VIRGINIA ELECTRIC AND POWER COMPANY (DOMINION)
NORTH ANNA POWER STATION UNIT NOS. 1 AND 2
RESPONSE TO REQUEST FOR ADDITIONAL INFORMATION ON PROPOSED
TECHNICAL SPECIFICATION CHANGES ON ADDITION OF ANALYTICAL
METHODOLOGY TO THE CORE OPERATING LIMITS REPORT (TAC NOS. MC7526
AND MC7527)

**Response to Request for Additional Information on Proposed Technical
Specification Changes on Addition of Analytical Methodology to the Core
Operating Limits Report
(Tac Nos. MC7526 and MC7527)**

**Virginia Electric and Power Company
(Dominion)
North Anna Power Station Units 1 and 2**

FIGURE 1-1

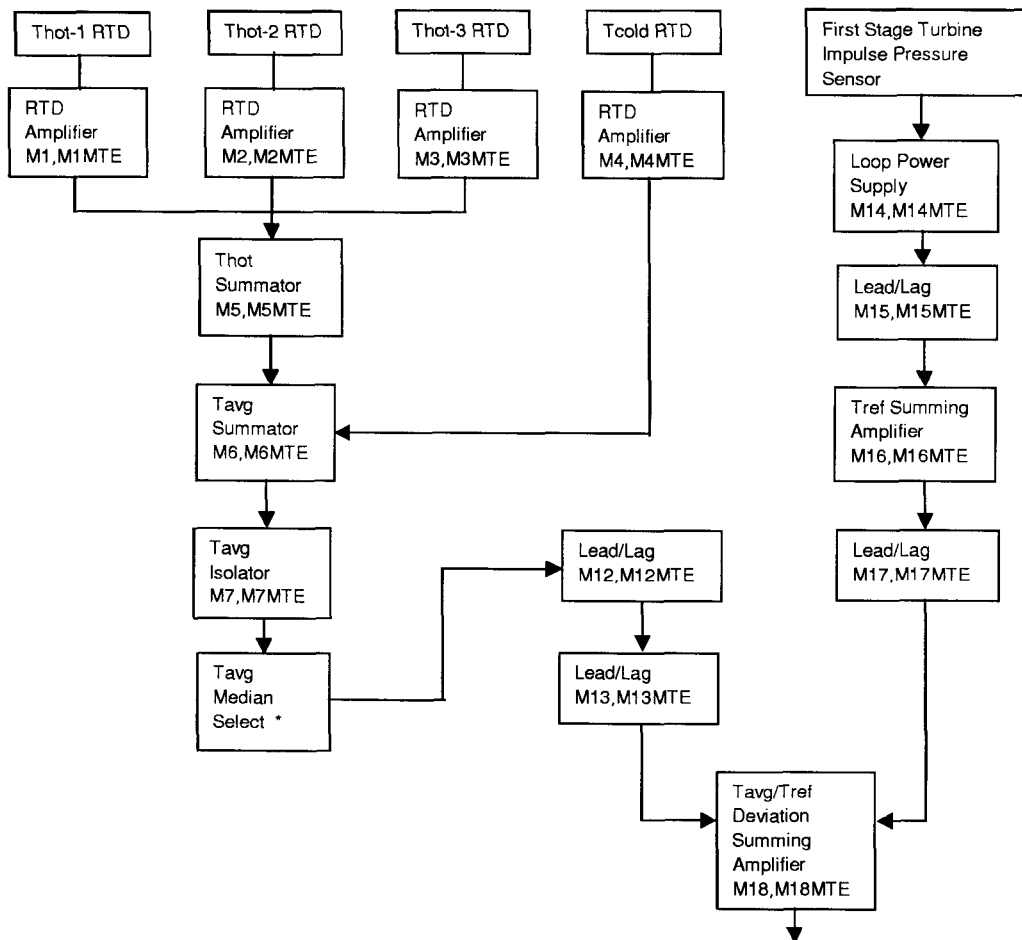
1. *Table 3.1.2-1 lists the uncertainties, probability distributions, nominal values and standard deviation of statistically treated parameters. These uncertainties and distributions deviate somewhat from that listed in Table 4.2-1 in Attachment 6 to Dominion Letter Serial No. 02-167 (L. N. Hartz to NRC, dated March 28, 2002).*

Provide the analyses performed to derive the uncertainty values and distributions of each of these parameters. The uncertainty analysis description should include, as appropriate, a block diagram depicting sensor, processing equipment, computer, and readout devices for each parameter channel. Within each element of the block diagram identify the accuracy, drift, range, span, operating limits, and setpoints. Identify the overall accuracy of each channel transmitter to final output and specify the minimum acceptable accuracy for use with the determination of the statistical design limit (SDL).

Dominion has quantified the magnitude and distribution of uncertainty on the pressurizer pressure (system pressure) per the pressurizer pressure control system. Figure 1-1 provides a simplified schematic of the pressurizer pressure control system. The current component accuracies for the pressurizer pressure control loop are shown in Table 1-1. In Reference 1, the pressurizer pressure uncertainty was quantified as a normal, two-sided, 95% probability distribution with a magnitude of $\pm 3.30\%$ of an 800 psi span or ± 26.4 psi. Subsequent to our submittal, the calculation was revised to reflect the inclusion of a revised STE (increase from 0.713% to 1.425%) for the pressure transmitter to reflect a wider variation in containment ambient temperature. The pressurizer pressure uncertainty is presently quantified as a normal, two-sided, 95% probability distribution with a magnitude of $\pm 3.55\%$ of an 800 psi span or ± 28.4 psi.

The pressurizer pressure uncertainty was conservatively applied in Reference 1 as a normal, two-sided, 95% probability distribution with a magnitude of ± 30 psia and a standard deviation (σ) of 15.306 psia. This assumed uncertainty represents the minimum required accuracy for the pressurizer pressure and bounds the quantified uncertainty.
